SERVICE BULLETIN

N° 189-245

ATA 33 - INSPECTION AND REINFORCEMENT OF SEARCHLIGHT SUPPORT

Figure 1

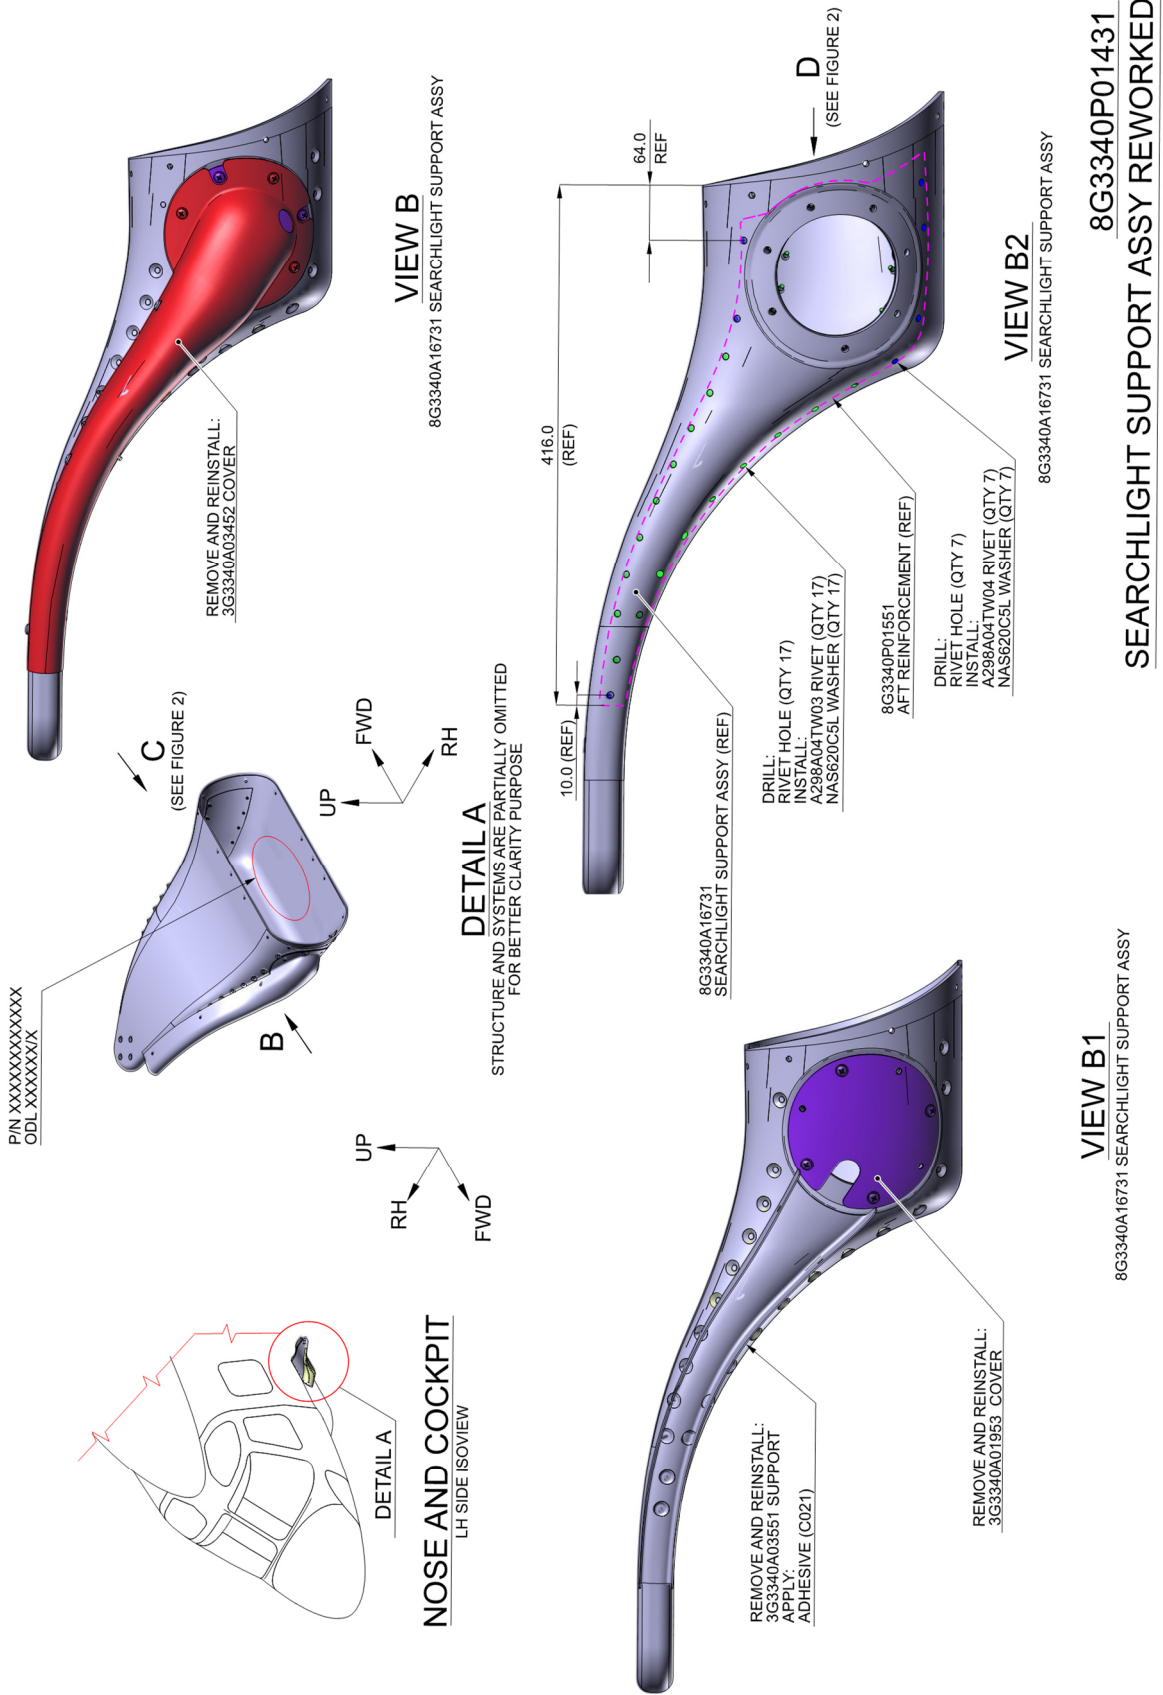
- 3.4 In accordance with AMP DM 89-A-33-47-03-00A-520A-B, remove the power conditioning interface unit from the searchlight support assy.
4. With reference to Figures 1 and 2, perform searchlight support assy retromod P/N 8G3340P01011 as described in the following procedure:
 - 4.1 With reference to Figure 1 View B, remove and retain for later reuse the cover P/N 3G3340A03452 and existing fasteners from the searchlight support assy P/N 8G3340A16731.
 - 4.2 With reference to Figure 1 View B1, remove and retain for later reuse the cover P/N 3G3340A01953 and existing fasteners from the searchlight support assy P/N 8G3340A16731.

- 4.3 With reference to Figure 1 View B1, carefully remove the support P/N 3G3340A03551 using a heat gun as described in the following procedure:
 - 4.3.1 Raise the temperature of the heat gun to 100 °C.

- 4.12 With reference to Figure 1 View B2 and Figure 2 View C, temporarily locate the AFT reinforcement P/N 8G3340P01551 and the FWD reinforcement P/N 8G3340P01651 in position on the searchlight support assy P/N 8G3340A16731.
- 4.13 With reference to Figure 1 View B2 and Figure 2 View C, countermark and drill n°51 rivet holes thru the searchlight support assy P/N 8G3340A16731.

- 4.14 With reference to Figure 1 View B2 and Figure 2 Section F-F, install the AFT reinforcement P/N 8G3340P01551 on the searchlight support assy P/N 8G3340A16731 by means of adhesive (C021), n°17 rivets P/N A298A04TW03, n°7 rivets P/N A298A04TW04 and n°24 washers P/N NAS620C5L.

- 4.19 With reference to Figure 1 View B, re-install the existing cover P/N 3G3340A03452 on the searchlight support assy P/N 8G3340A16731 by means of existing fasteners previously removed.
- 4.20 With reference to Figure 2 View D, remark the reworked searchlight support assy as P/N 8G3340P01011 by means of an indelible pen.

Figure 2

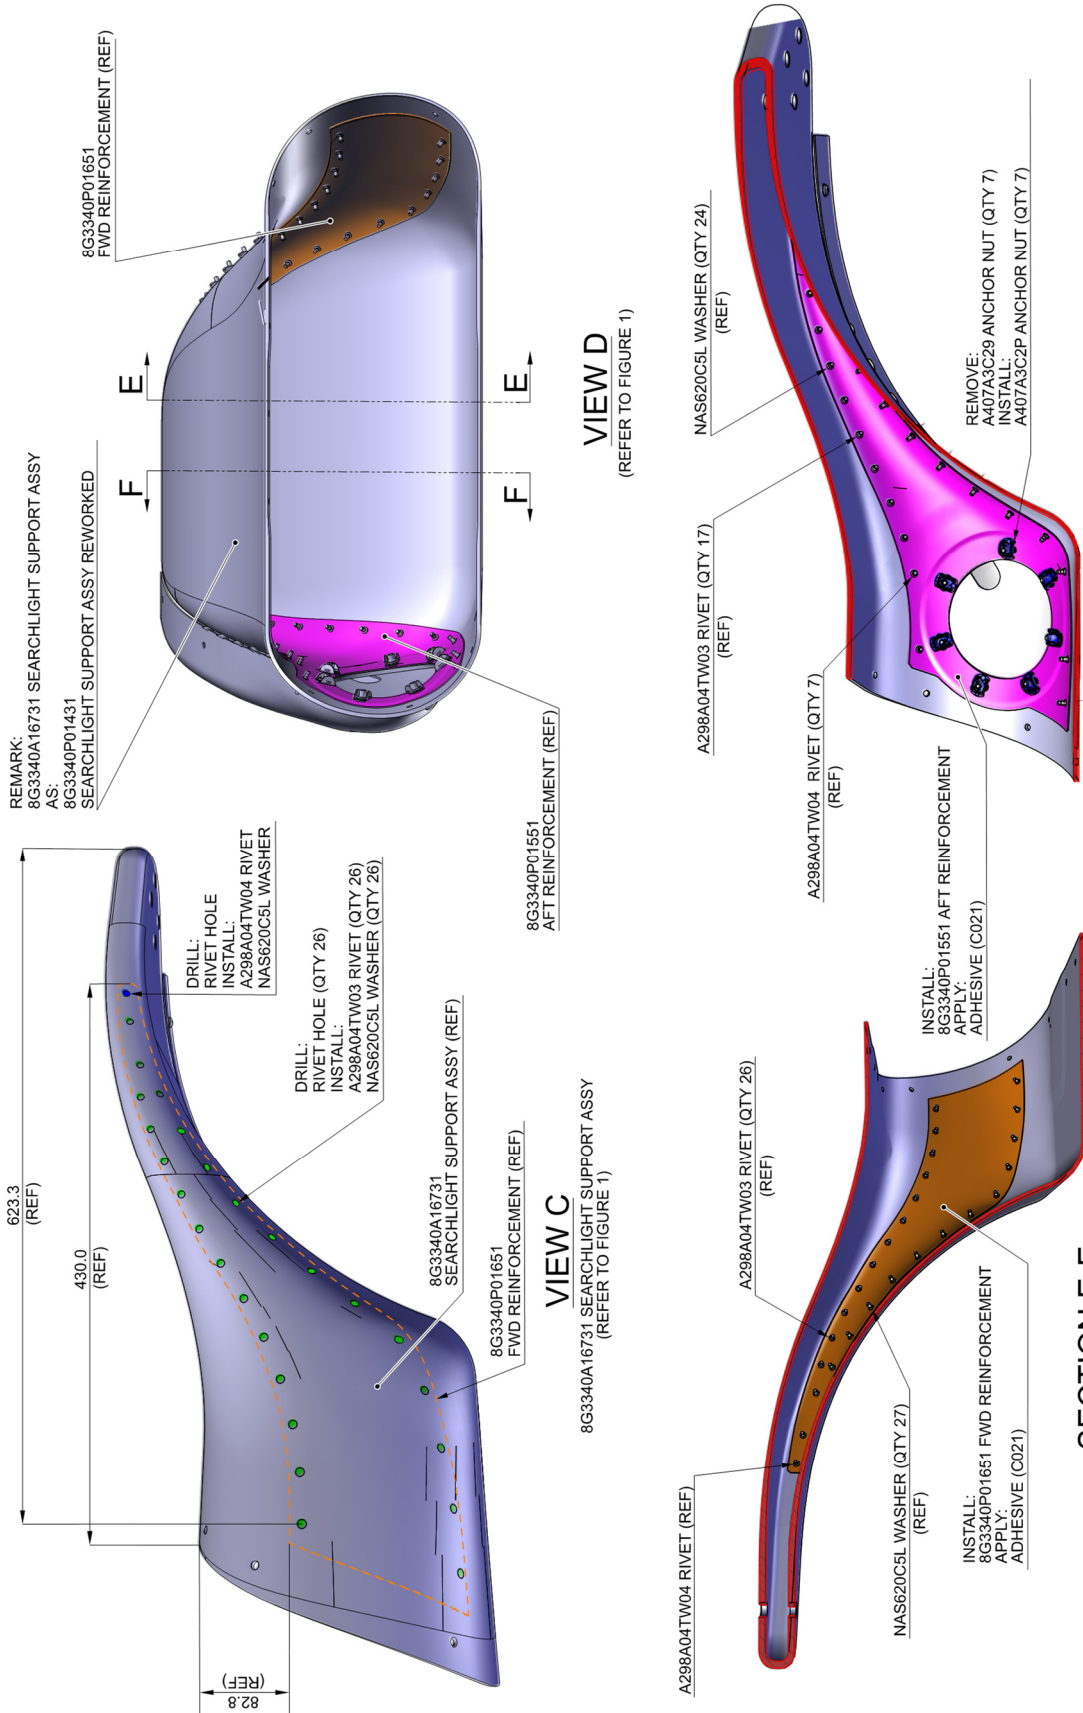
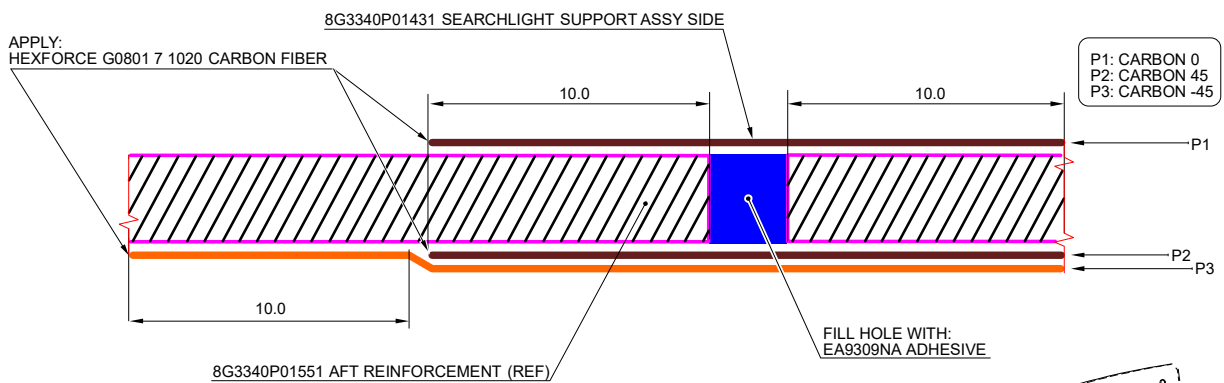
- 4.4 With reference to Figure 2 Section F-F, remove n°7 anchor nuts P/N A407A3C29 from the searchlight support assy P/N 8G3340A16731.
- 4.5 With reference to Figure 3 View G, perform a trim on the edge of the profile of the AFT reinforcement P/N 3G3340A17952.

- 4.15 With reference to Figure 2 View C and Section E-E, install the FWD reinforcement P/N 8G3340P01651 on the searchlight support assy P/N 8G3340A16731 by means of adhesive (C021), n°26 rivets P/N A298A04TW03, n°1 rivet P/N A298A04TW04 and n°27 washers P/N NAS620C5L.
- 4.16 With reference to Figure 2 Section F-F, install n°7 anchor nuts P/N A407A3C2P on the AFT reinforcement P/N 8G3340P01551 by means of adhesive C021.
- 4.17 With reference to Figure 1 View B1, re-install the existing support P/N 3G3340A03551 previously removed on the searchlight support assy P/N 8G3340A16731 by means of adhesive (C021).
- 4.18 With reference to Figure 1 View B1, re-install the existing cover

Figure 3

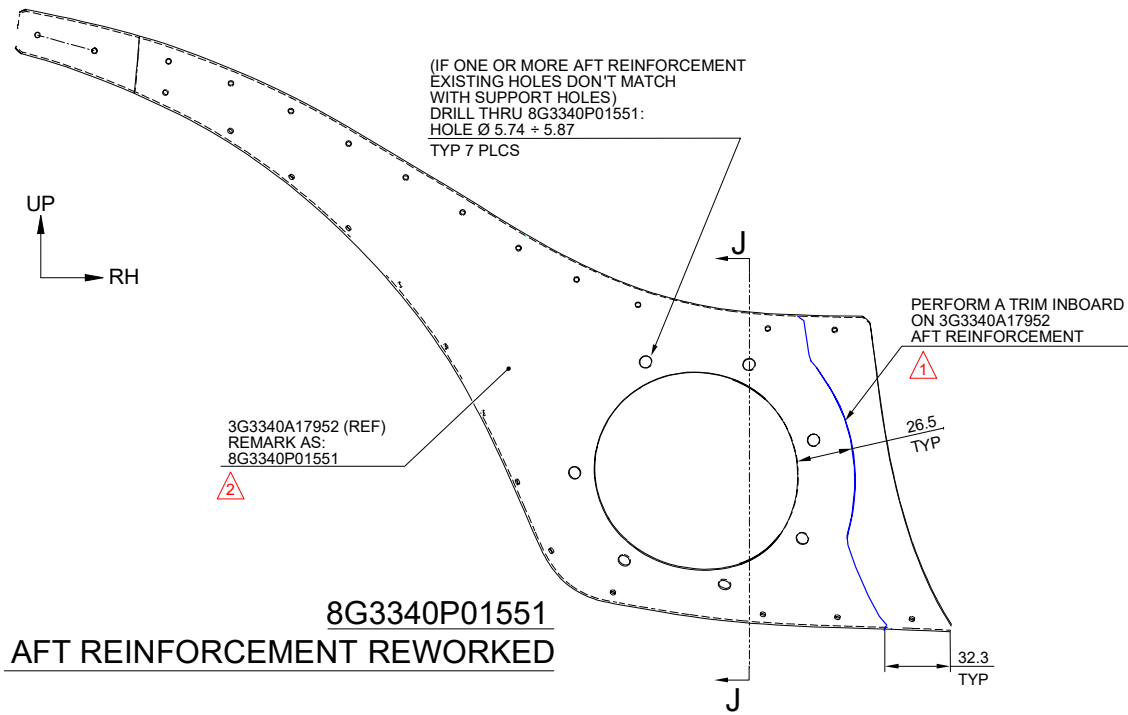
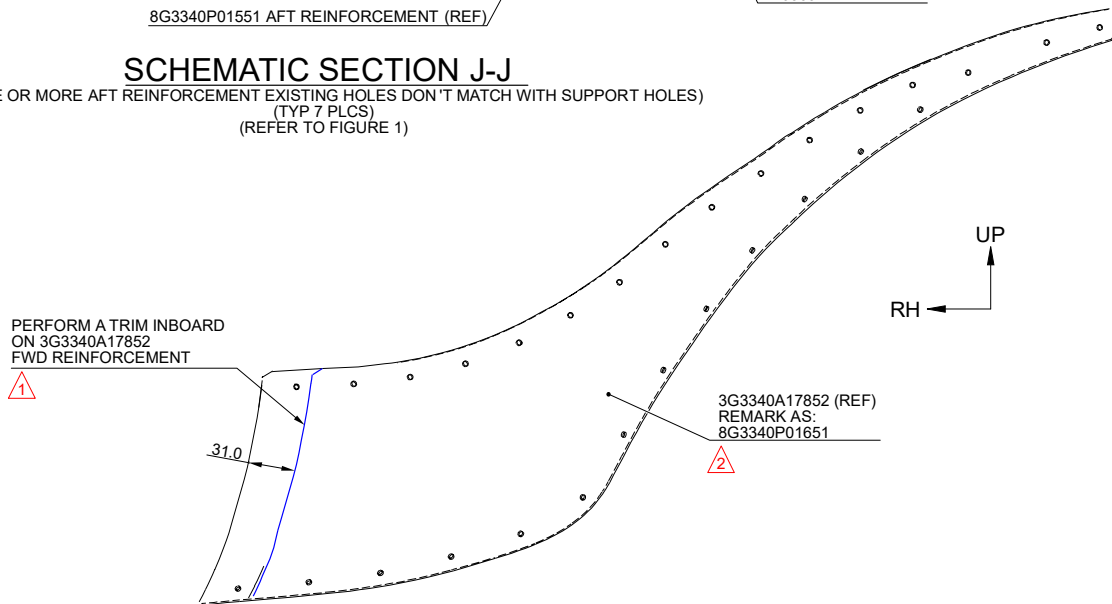
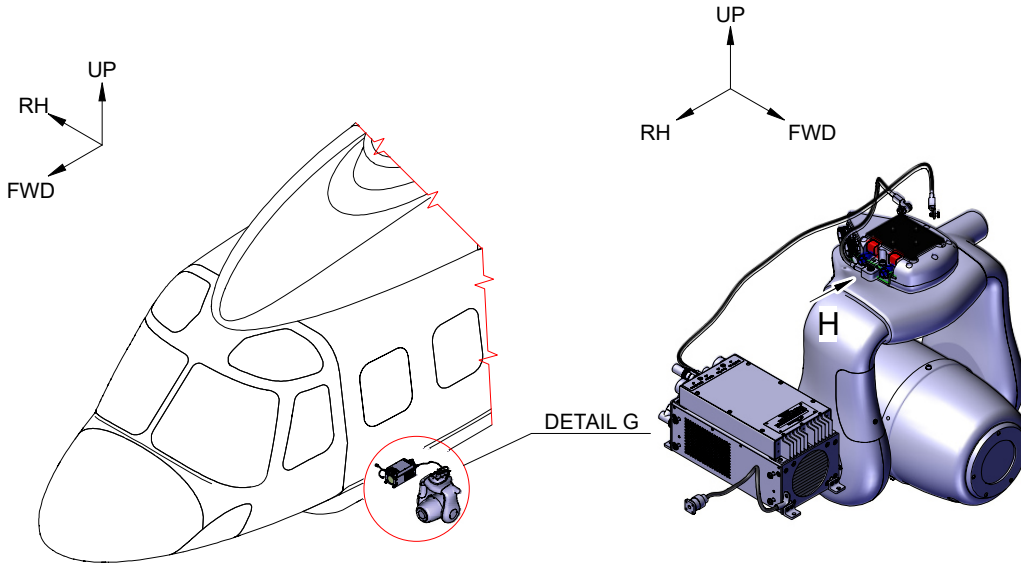
- 4.7 With reference to Figure 3 View G remark the reworked AFT reinforcement as P/N 8G3340P01551 adjacent to existing detail part mark.
- 4.8 With reference to Figure 3 View H perform a trim on the edge of the profile of the FWD reinforcement P/N 3G3340A17852.

- 4.10 With reference to Figure 3 View H, remark the reworked FWD reinforcement as P/N 8G3340P01651 adjacent to existing detail part mark by means of an indelible pen.

- 4.11.1 With reference to Figure 3 Section J-J, apply a layer (P1) of Carbon fiber dry fabric HexForce G0801 7 1020 and let it cure.
- 4.11.2 With reference to Figure 3 Section J-J, fill 7 screw holes with EA9309NA.
- 4.11.3 With reference to Figure 3 Section J-J, apply a layer (P2 and P3) of Carbon fiber dry fabric HexForce G0801 7 1020 and let them cure.
- 4.11.4 In accordance with CSRP-A-51-21-02-00A-028A-D, protect repaired area with primer.
- 4.11.5 With reference to Figure 3 "8G3340P01551 aft reinforcement reworked", countermark and drill n°7 screw holes $\varnothing 5.74 \div 5.86$ thru the aft reinforcement.

Figure 4

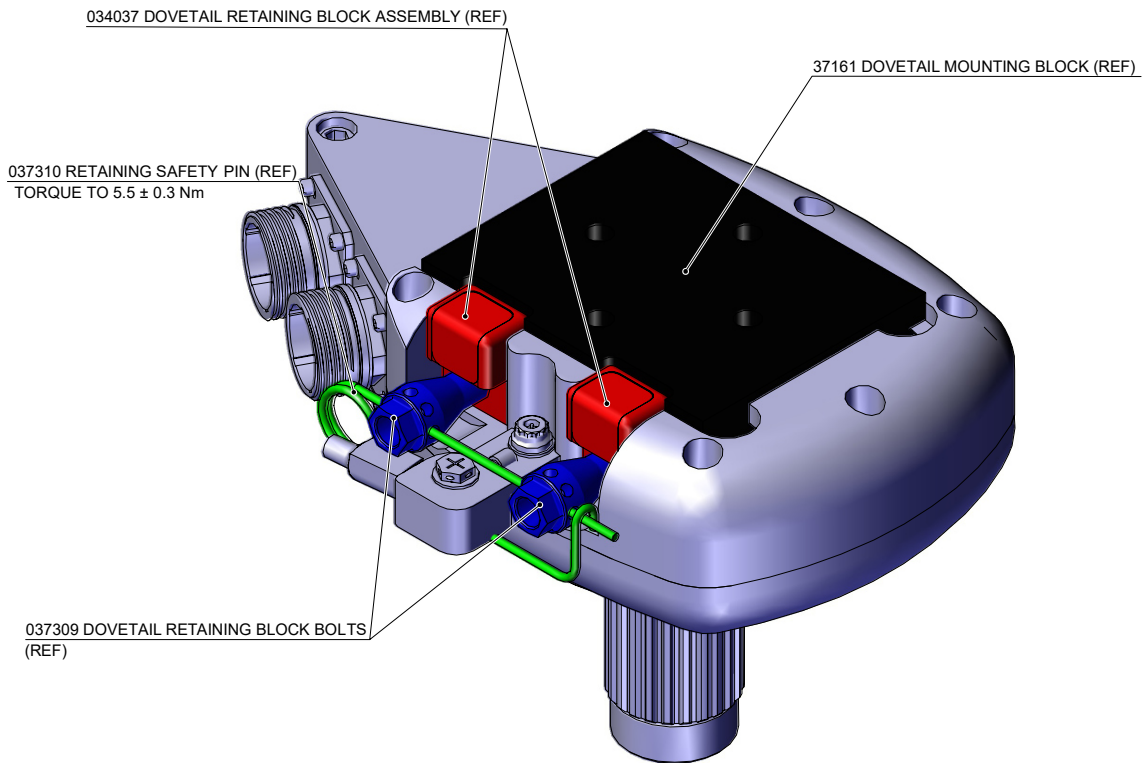
1. In accordance with AMP DM 89-A-00-20-00-00A-120A-A, prepare the helicopter on ground for a safe maintenance. Disconnect the battery, all electrical power sources and/or the external power supply.
2. In accordance with AMP DM 89-A-06-41-00-00A-010A-A gain access to the area affected by the installation.
3. With reference to Figure 4 View H, remove and retain for later reuse the retaining safety pin P/N 037310.
4. With reference to Figure 4 View H, tighten the dovetail retaining block bolts P/N 037309 to a torque of 5.5 ± 0.3 Nm.

If the holes in the retaining bolts do not line up, tighten the two bolts until the holes line up and the safety pin can be inserted. Do not loosen the bolts or retaining them more than 6.5 Nm to achieve this.

5. With reference to Figure 4 View H, insert the retaining safety pin P/N 037310 through the matching holes in the heads of the dovetail retaining bolts P/N 037309 in the direction shown in the illustration.
6. Return the helicopter to flight configuration and record for compliance with Part II of this Service Bulletin on the helicopter logbook.
7. Send the attached compliance form to the following mail box:
